Access Compliance Report Public Rights-of-Way (Pedestrian Signals)

Main Street: **CARBON_CANYON_RD** Cross Street: **SANTA_FE_AVE** Location: **SE**

ADA ID: **SGAT210920125339** Signal Type: **One Push Button-APS** Overall Compliance: **No** Severity Scores: **BTN 1: 0** **BTN 2: N/A** **No BTN: N/A**

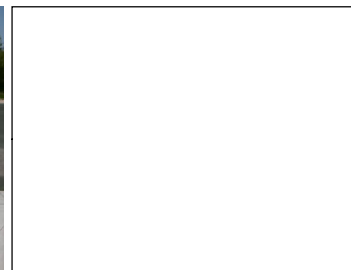
Yes	B 1 Diameter (in)	2.25	N/A	B 2 Diameter (in)	N/A
N/A	B 1 Crossing Direction	W	N/A	B 2 Crossing Direction	N/A
Yes	B 1 DistanceTo XWalk (in)	0	N/A	B 2 DistanceTo XWalk (in)	N/A
No	B 1 DistanceTo Curb (in)	94	N/A	B 2 DistanceTo Curb (in)	N/A
	Parcel Identification Number	322-031-23			
	Google Street View Link				
	http://www.google.com/maps/@?api=1&map_action=pano&viewpoint=33.92222866,-117.83688864

Possible Solutions: Replace Signal Push Button With APS Button. Remove & Relocate Sign.
